# University of Kentucky<sup>®</sup>

CCK-2564.0-9-24

Construct Health Education Building

ADDENDUM #3

**E** COMM DUCT THROUGH BASEMENT WALL DETAIL  
1/2" = 1'-0"

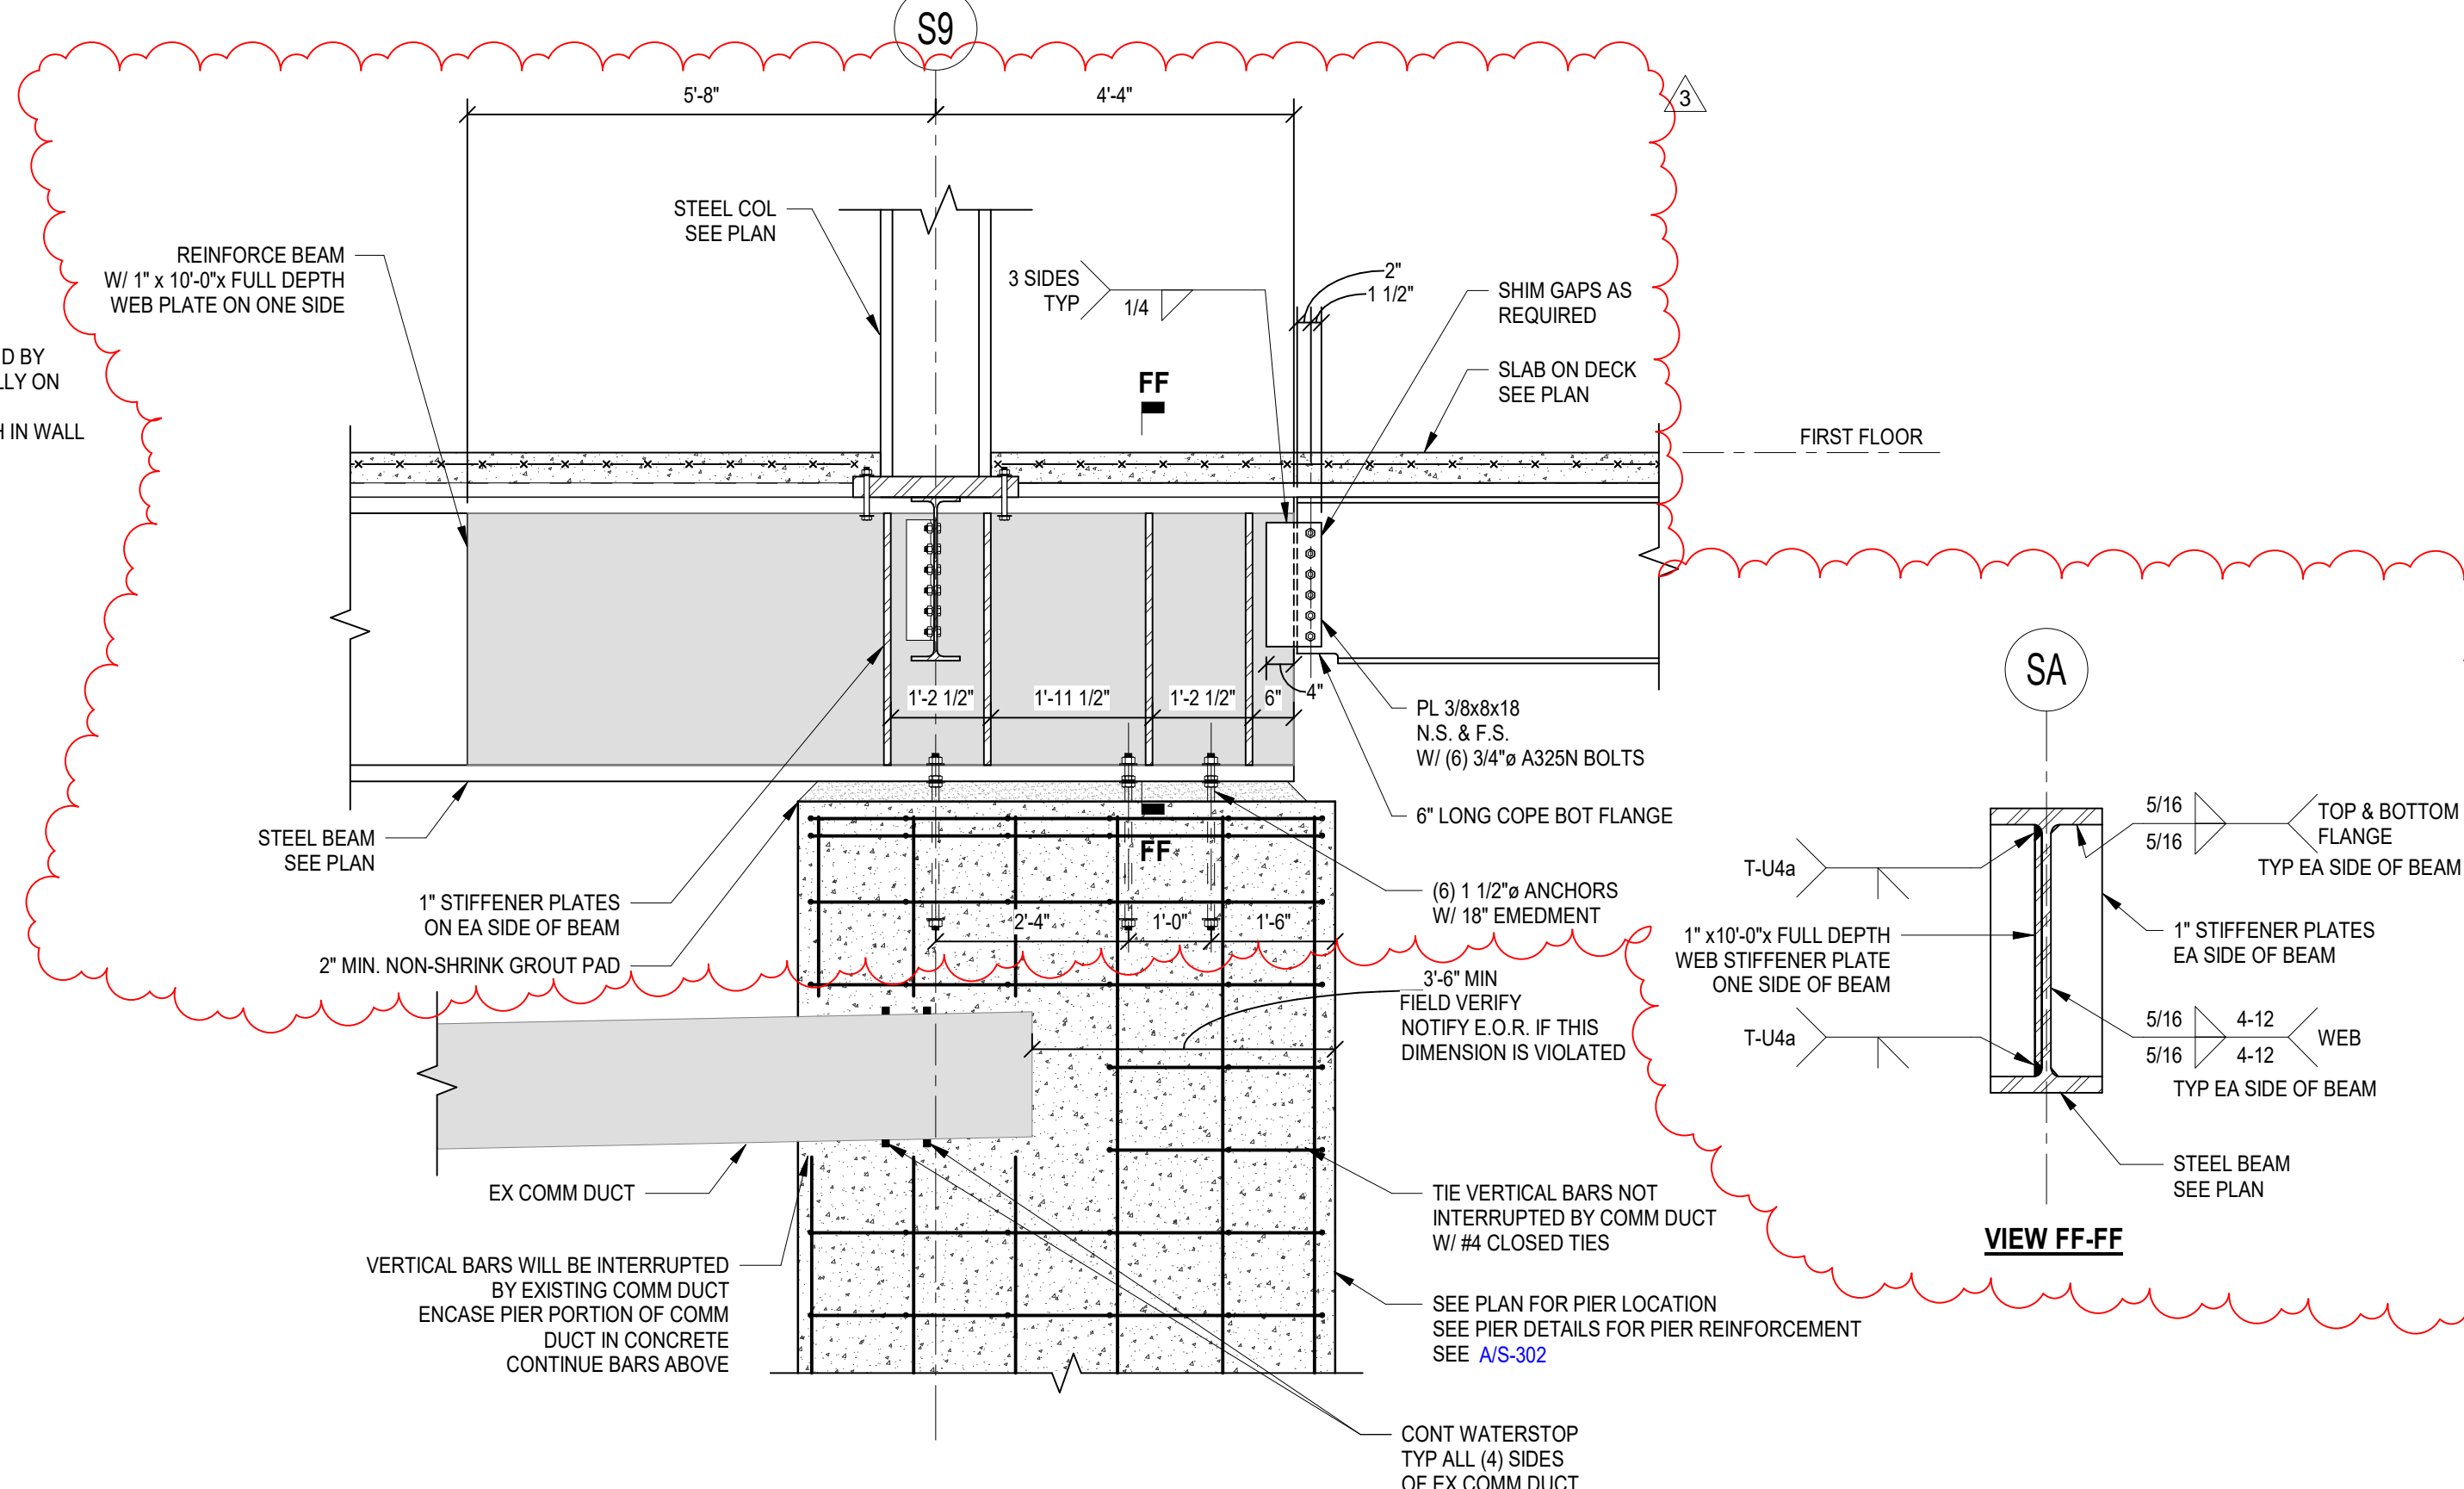
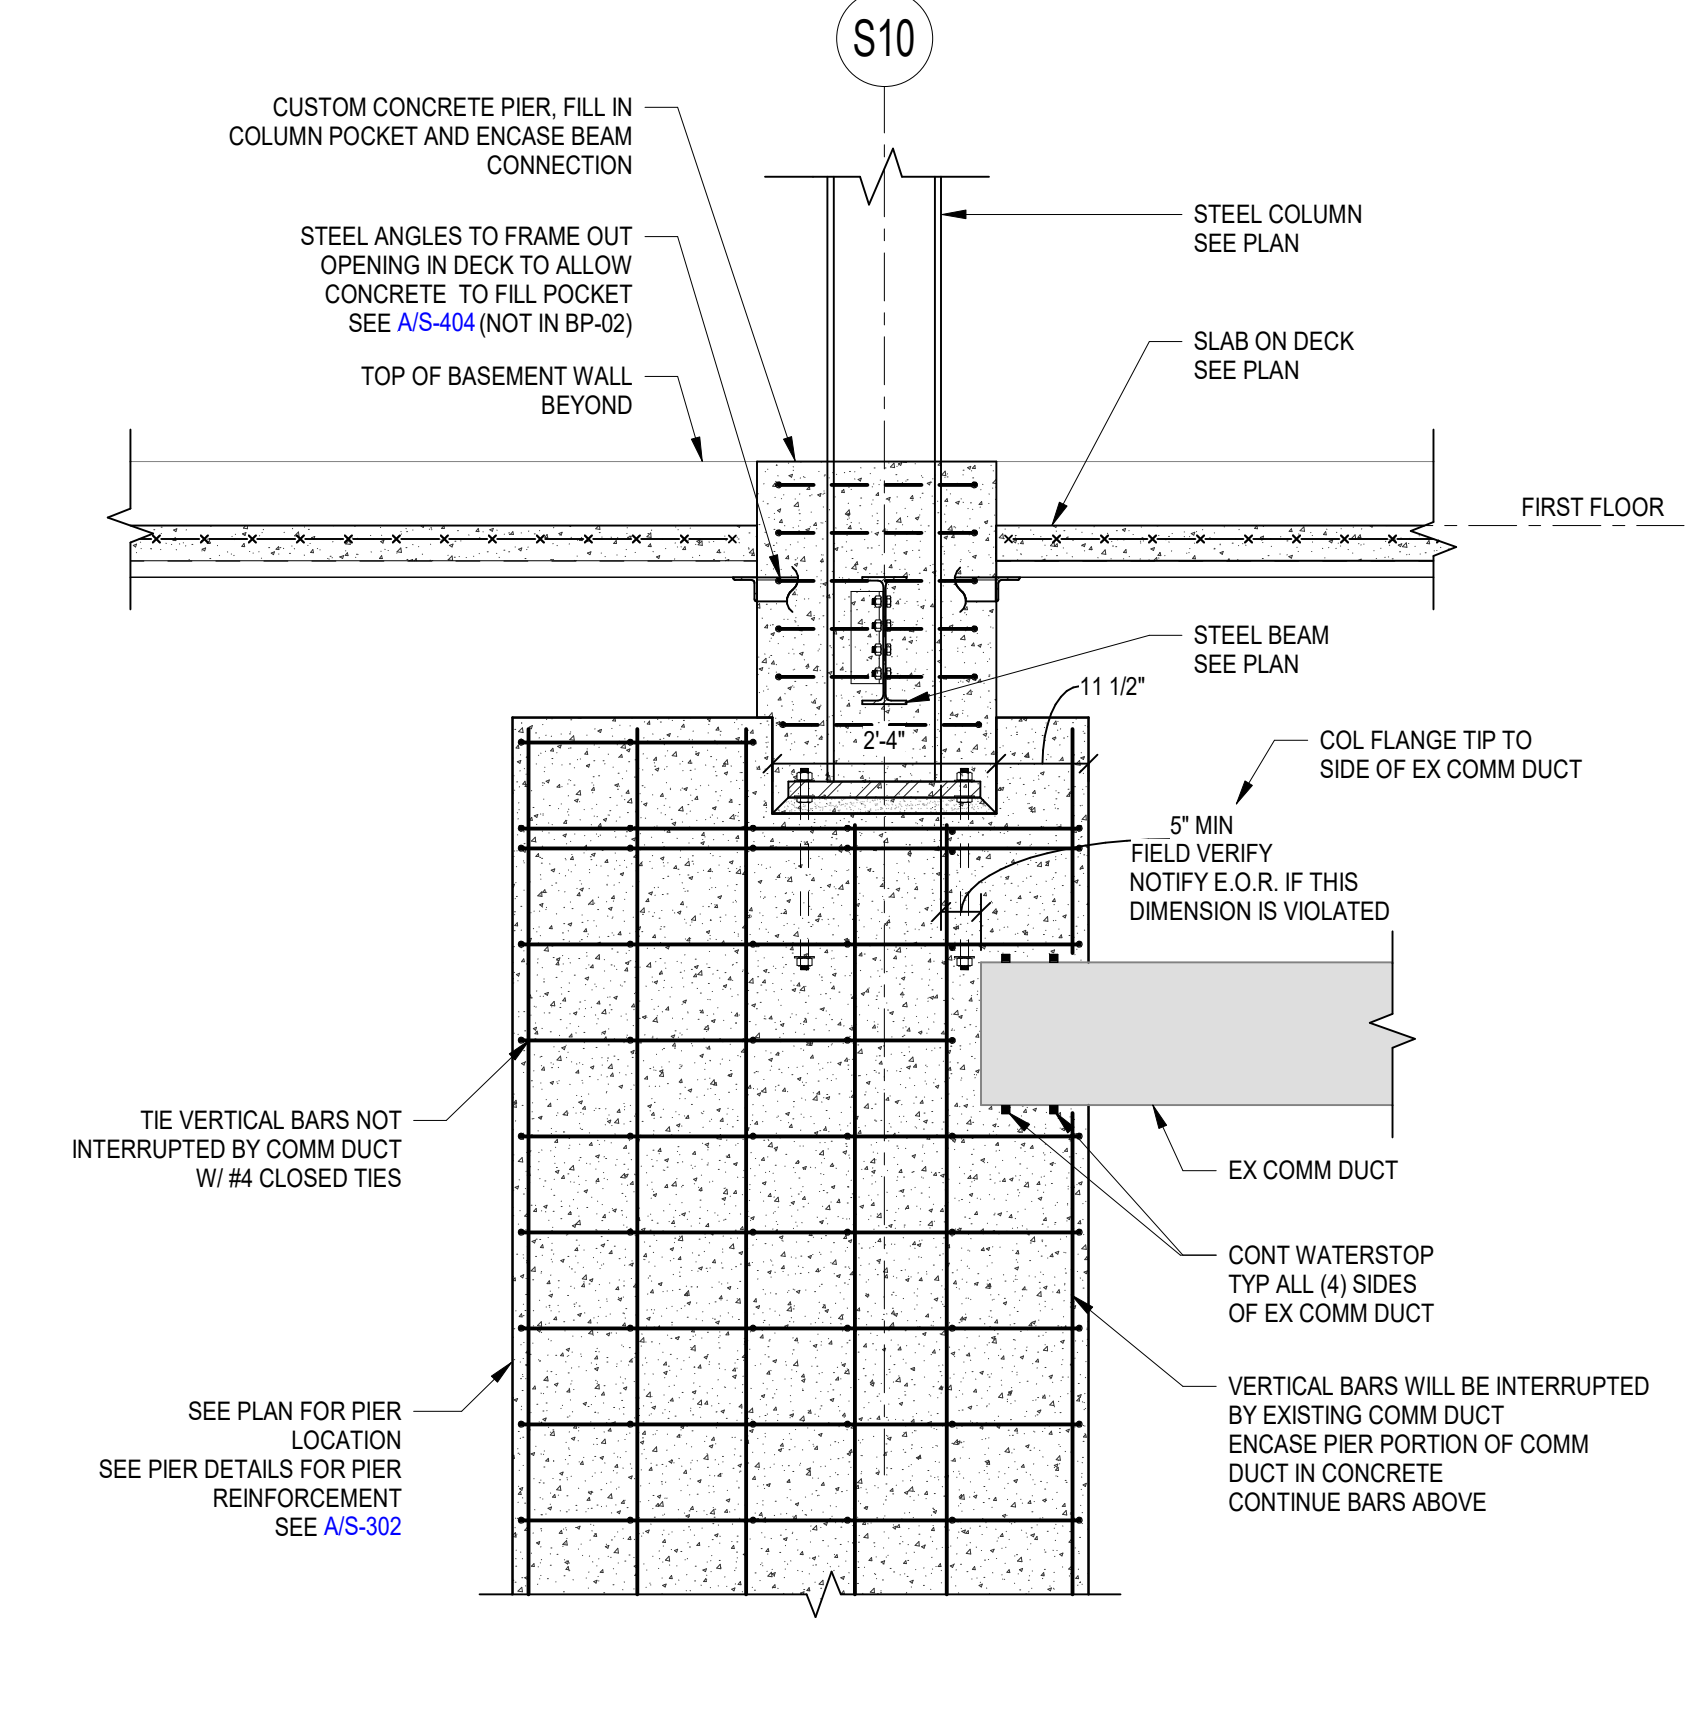
Refer to attached sheet S-302. Updated pier sizes and reinforcement. Added additional pier types.

**MU-202**

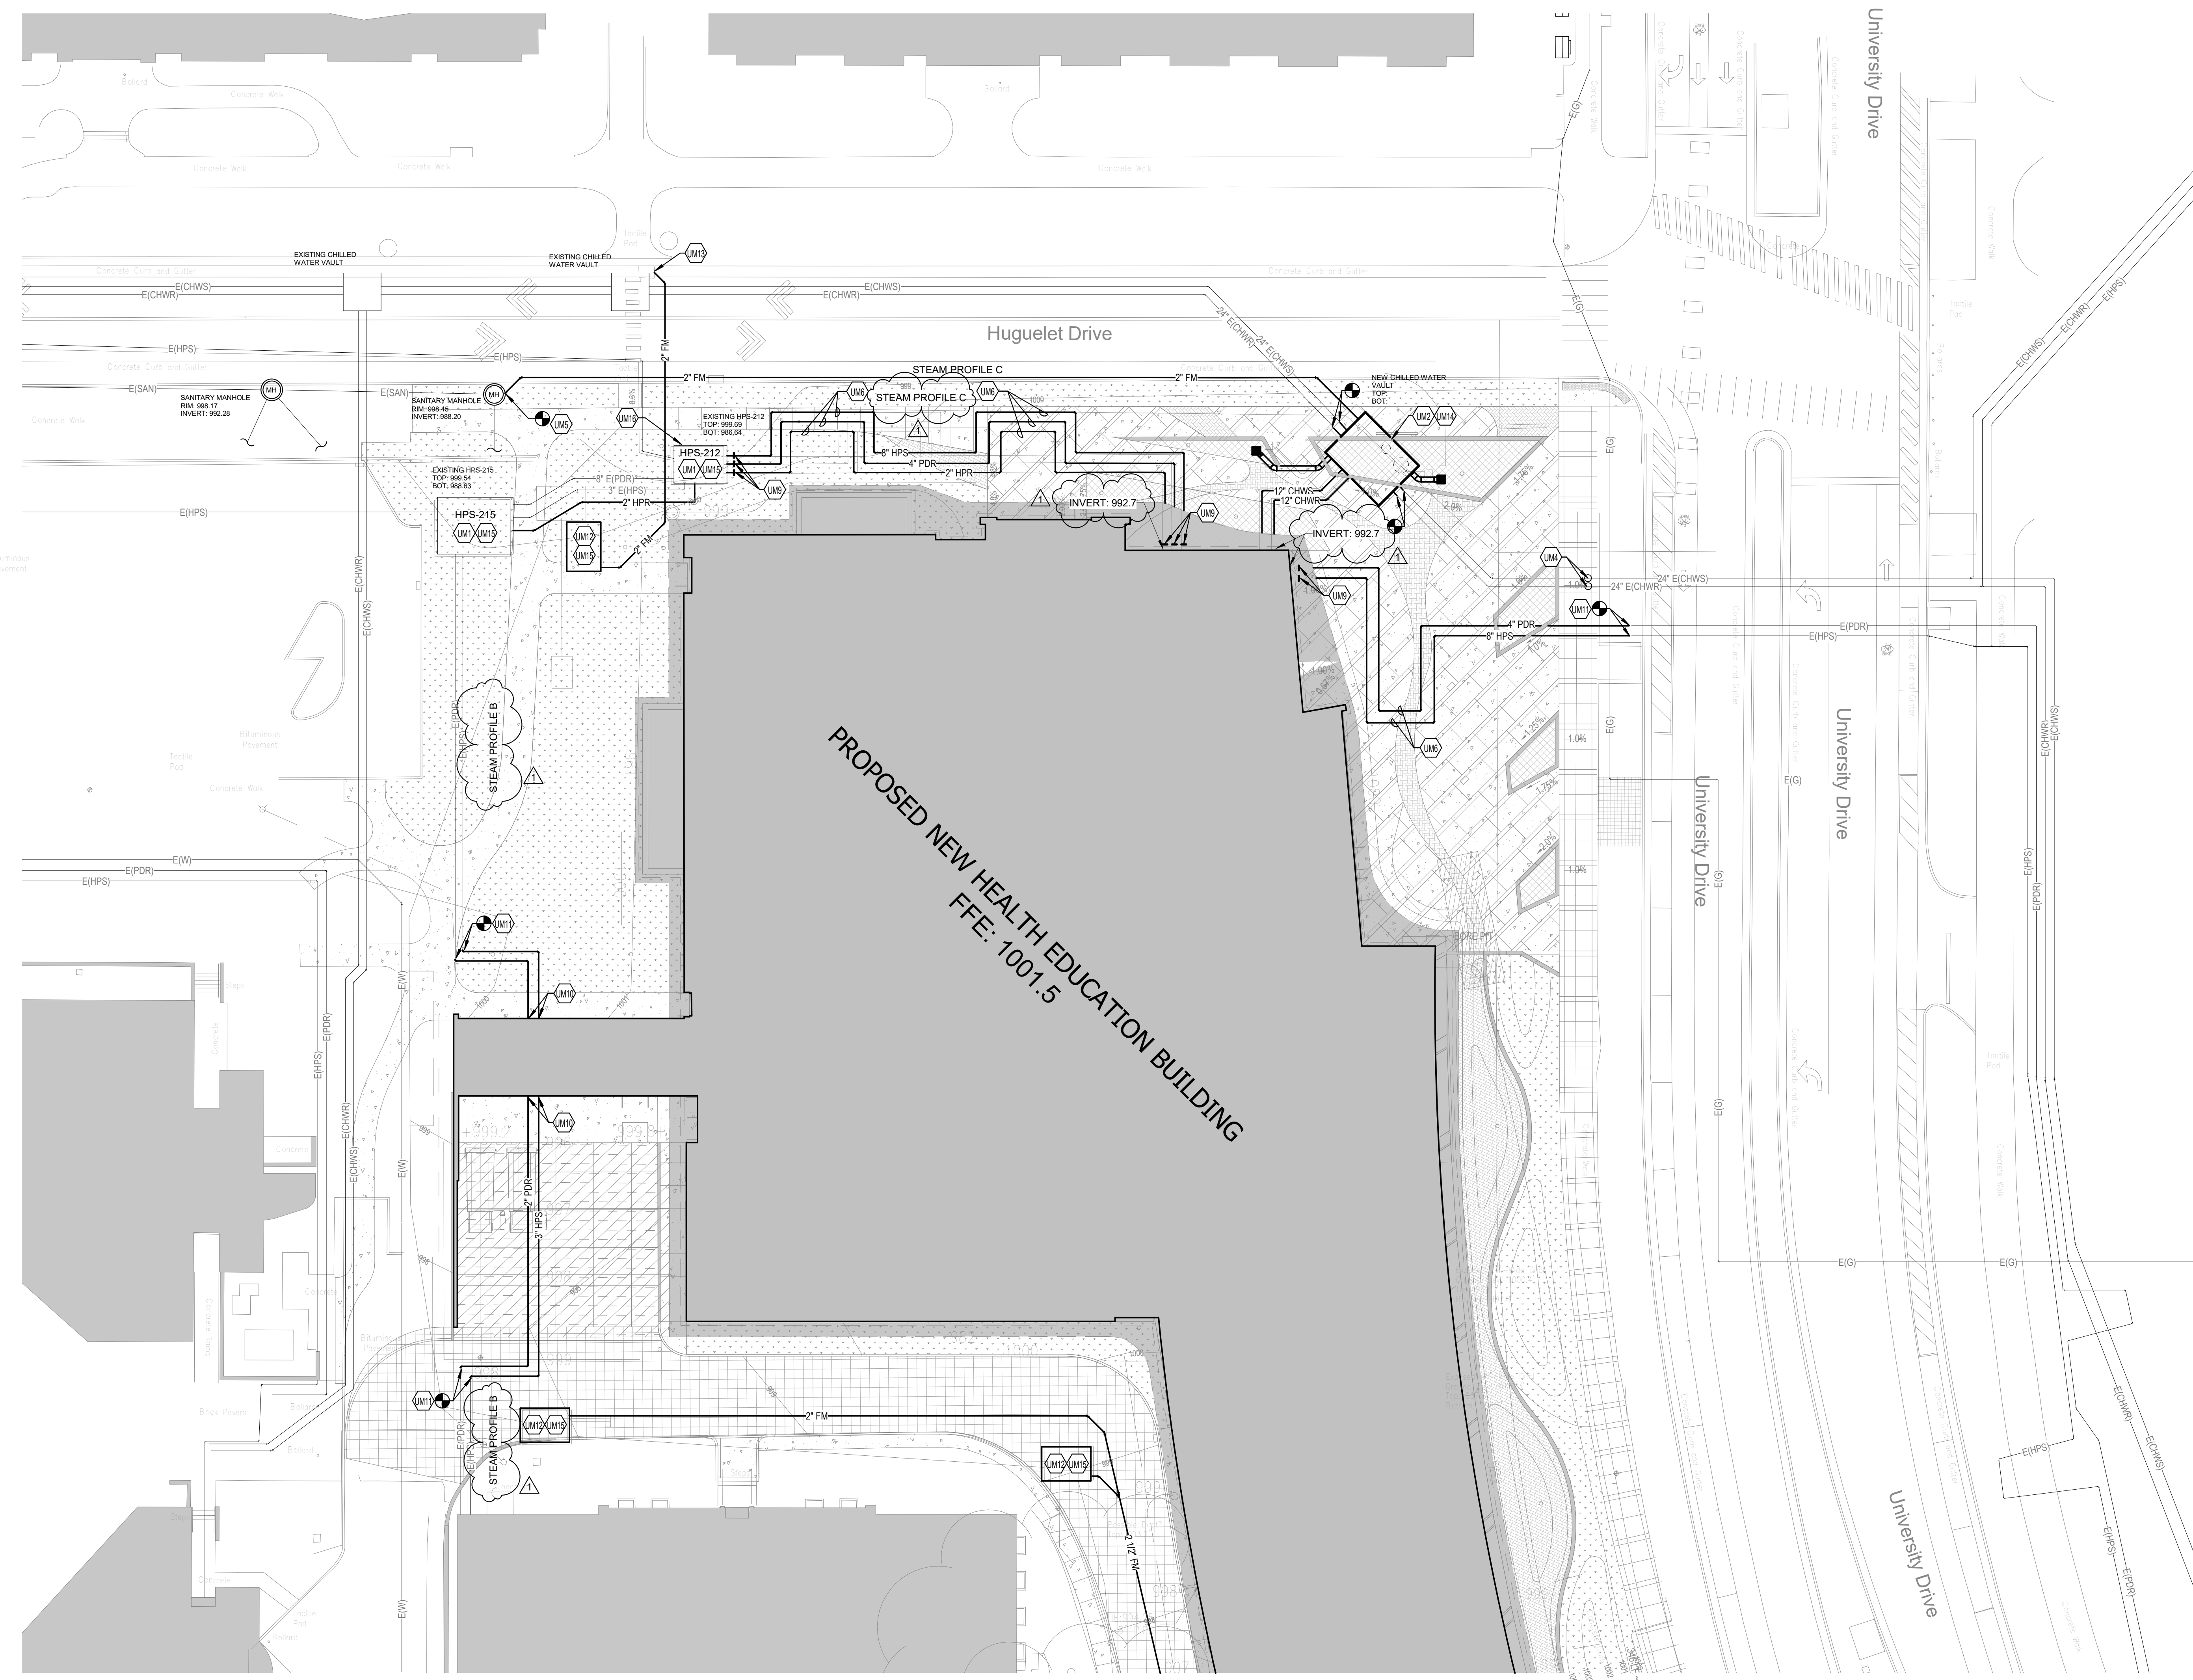
Refer to the Mechanical Drawings. Mechanical Drawings shall be renumbered to be sequential with BP-1 site plans. Refer to the attached drawings. Item #2 Refer to Mechanical Drawing MU-202
